DISCUSSION.

L. S. Akin²

Author's Closure

Fig. 10 Tooth interference with oil jet at two different jet positions

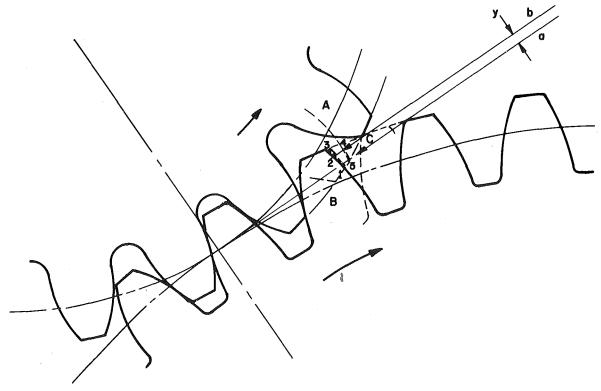
1 Fig. 3 in the paper shows the jet stream line pointed toward the mesh pitch point. In large reduction gears like those used in marine and power plant applications, such a scheme may let the jet miss the drive pinion "a" entirely as shown in the discusser's schematic Fig. 10. Jet stream line "a" impinges on gear tooth "b" only. If the jet stream line is moved over to position "b" coinciding with the common intersection of the outside diameters "c," the impingement depth on tooth b is reduced from 1–3 to 2–3. But the cooling oil is now shared with the pinion tooth "a," as shown in the dotted position now being cooled from 4 to 5. Generalizing, the jet stream line can be placed at various positions "y" from position "a" to gain whatever cooling proportionment is desired—for example, forcing all of the coolant to impinge on the pinion instead of the gear. This may be considered

desirable in some cases when one wishes the "loaded" or working side of the tooth to be cooled as much as possible. A separate jet directed in a radial or optimum direction can be provided for each gear individually to provide a much better solution, as the authors have asserted.

With regard to disengaging lubrication of large gears, the authors agree with Mr. Akin's remarks.

Fig. 11 Kinematics of jet impingement on a tooth

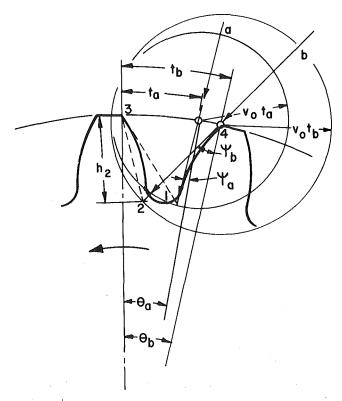
2 In Fig. 4(b) of the paper, the author asserts that with the jet set at any angle ψ between ψ_{\max} and ψ_{\min} , it is not possible to get the oil to penetrate below Point B at the intersection of the profile tangent $\overline{BO_0}$ and the reverse "line of action" \overline{SB} , especially if the jet stream is directed along the line \overline{SB} . He further implies (perhaps unintentionally) that it is not possible to impinge directly on the load side of a driven gear. The discusser would like to make the mechanics of this portion of the problem clearer for the reader using his Fig. 11. It is possible to get all the way to the root or to any depth desired (h_v) on either side of the tooth by setting v high enough so that $vt_i = h_v/\cos \theta$ and to the proper angle ψ_i , where h_v , v and θ are defined in reference [10] and the subscript i refers to any specifically selected t and ψ (per the authors' definition).

Two specific examples are shown in the discusser's Fig. 11. In the first example, it is desired to cool the entire loaded face of the driver with the jet directed along stream line "a." Here for given velocities v_o and v_b the jet position angle ψ_a cannot be larger than the angle between the tangent line at the desired depth of impingement (Point 1, in this case) to avoid premature contact with the tooth profile. Also, significantly smaller ψ_i angles would require an increase in the value for v_{α} in that t_{α} (time required for gear to rotate through angle θ_{α} would be smaller and h_a must be maintained at a fixed value to keep the size of the penetration circle a constant. Thus, as the gear rotates relative to the nozzle, the oil jet stream penetrates to a position along the dotted line 1-3, as was shown in the discusser's reference [2] as Fig. 6. This same figure also shows that the loaded (or back) side of the driven gear can also be cooled by jet impingement if the jet stream is directed along the line "b" toward impingement point "2" if the nozzle is set at ψ_b , and v_o is selected so that $v_o t_b = h_b / \cos \psi_b =$ (the authors' r_{ℓ} to point "2"). In this case, the oil jet stream penetrates to a position along the dotted line 2-3 and terminates as point "2" in the time t_b (while gear rotates through angle θ_b) where the leading force of the trailing tooth chops the jet stream off as shown at "4." Here it will be noted that for the given t_b and v_b the angle ψ_b must be larger than the angle between the tangent to the profile at "4" and the radius vector from the center of the gear through "4". If ψ_b is made smaller, then t_b will have to be reduced and v_o increased in order to continue to intercept the point "2" at the desired impingement depth h_b .

Generalizing, ψ_i should be made as large as necessary, within the above restraints, to keep v_o as small as possible for the impingement depth h_i desired. The fact that v_o varies with the square root of the pressure makes minimizing v_o very important in a high-speed drive. Thus it can be shown that the minimum velocity needed to jet cool the working (loaded) side of the driven gear is:

$$v_{o\min} \doteq \frac{h_2 n_i}{30(2/N_i - T_\ell/\pi R_o)\cos\psi_{\rm b}} \text{ in./s}$$

In Section 2.3, the authors considered the lubrication of leading flank. Fig. 4(b) shows the state that the tip of the oil jet stream just reached any fixed point B on the leading flank. Point B is the bottom point where an oil supply is desired when the oil supply angle is Ψ . The line BO₀ is not tangent to point B. Equations (15)–(18) can be applicable to any spur gear pair if the oil jet is not obstructed by the mating gear. At $\Psi = \Psi_{\min}$, v_0 becomes infinite because the tip of

where v_p is the circumferential velocity of reference pitch circle. Table 3 shows the value of Ψ_{\max} and $v_{0\min}/v_p$ at $\alpha_c = 20$ deg and $\Psi = \Psi_{\max}$. The first column is the value of Ψ_{\max} , the second column is the value of equation (22), and the third column is the value of Mr. Akin's equation. The empty column shows the pointed tooth. When undercut occurs, point E is selected as the origin of involute curve. As is shown in the table, $v_{0\min}$ is not affected greatly by the values of z and x, and it is sufficient to take $v_{0\min}$ equal to $1 \cdot 1v_p$ in any condition. The values of Mr. Akin's equation. The difference between the two is great when z and x are small.
